PCI-SIG ENGINEERING CHANGE NOTICE

| TITLE: | Training Error Removal |
| AFFECTED DOCUMENT: | PCI Express Base Specification Revision 1.0a |

Figure 7-18: Link Status Register

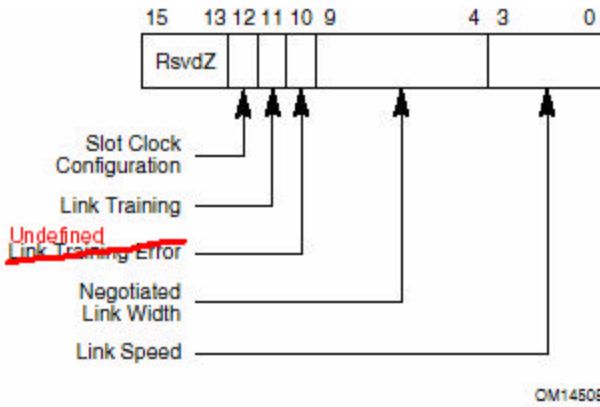
| Bit Location | Register Description | Attributes |
|--------------|--|------------|
| 10 | <p>Training Error – This read-only bit indicates that a Link training error occurred.</p> <p>This field is not applicable and reserved for Endpoint devices and Upstream Ports of Switches.</p> <p>This bit is cleared by hardware upon successful training of the Link to the L0 Link state.</p> <p>Undefined – The value read from this bit is undefined. In previous versions of this specification, this bit was used to indicate a Link Training Error. System software must ignore the value read from this bit. System software is permitted to write any value to this bit.</p> | RO |

Figure 7-28: Uncorrectable Error Status Register

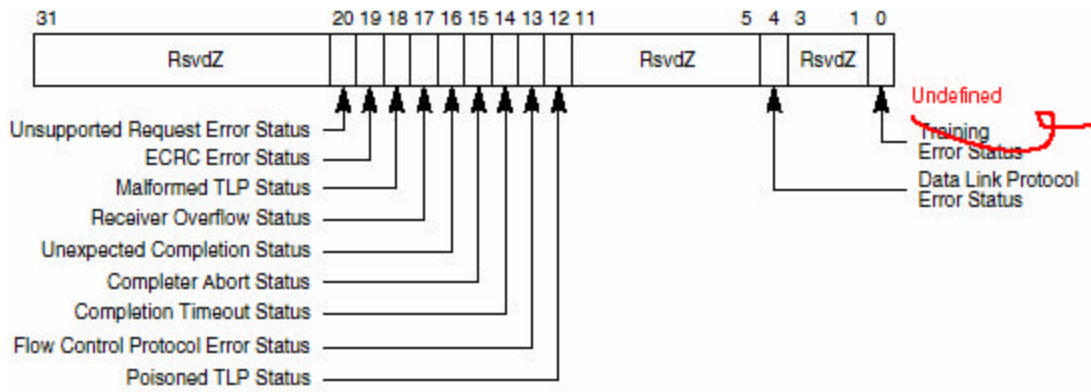
In Figure, label bit 0 (indicated) as RsvdZ-

| Bit Location | Register Description | Attributes | Default Value |
|--------------|---|-------------------------------|----------------|
| 0 | Training Error Status (Optional) Undefined - The value read from this bit is undefined. In previous versions of this specification, this bit was used to indicate a Link Training Error. System software must ignore the value read from this bit. System software is permitted to write any value to this bit. | RW1CS Undefined | 0 Undefined |

Figure 7-29: Uncorrectable Error Mask Register

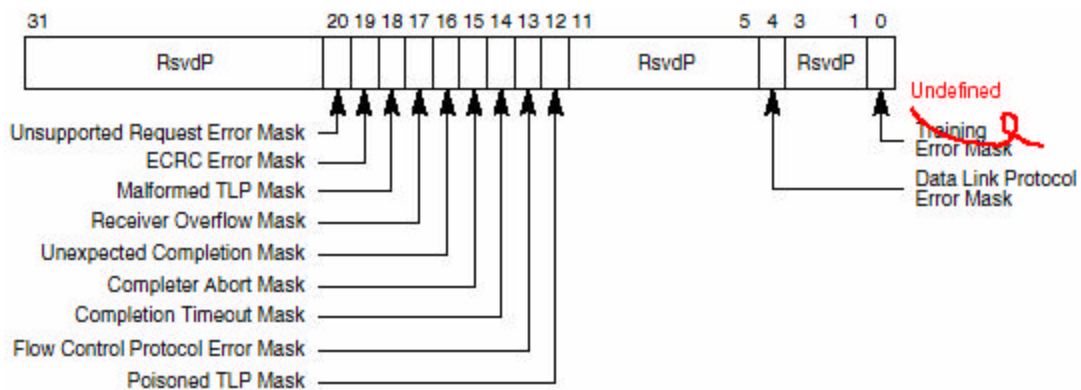
In Figure, label bit 0 (indicated) as RsvdP-

| Bit Location | Register Description | Attributes | Default Value |
|--------------|--|------------------|----------------|
| 0 | Training Error Mask (Optional) Undefined - The value read from this bit is undefined. In previous versions of this specification, this bit was used to mask a Link Training Error. System software must ignore the value read from this bit. System software must only write a value of 1b to this bit. | RWS Undefined | 0 Undefined |

Figure 7-30: Uncorrectable Error Severity Register

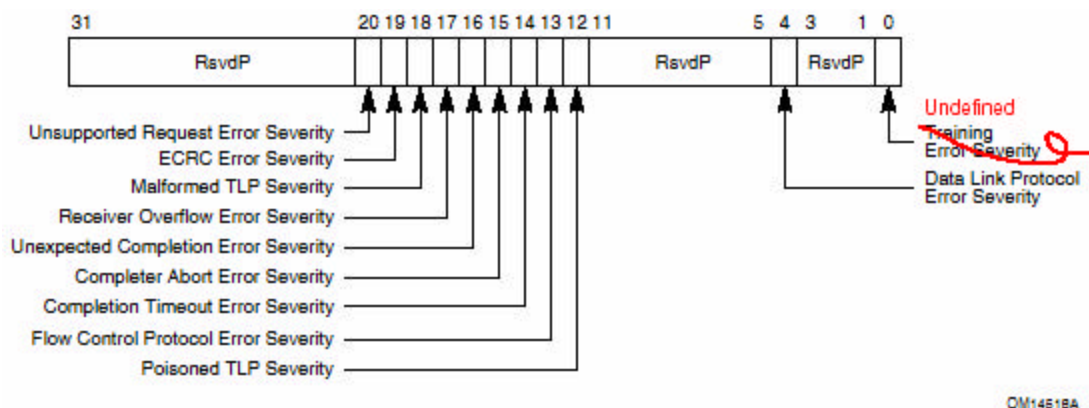
In Figure, label bit 0 (indicated) as RsvdP-

| Bit Location | Register Description | Attributes | Default Value |
|--------------|---|------------------|----------------|
| 0 | Training Error Severity (Optional) Undefined - The value read from this bit is undefined. In previous versions of this specification, this bit was used to set the severity of a Link Training Error. System software must ignore the value read from this bit. System software is permitted to write any value to this bit. | RWS Undefined | 1 Undefined |
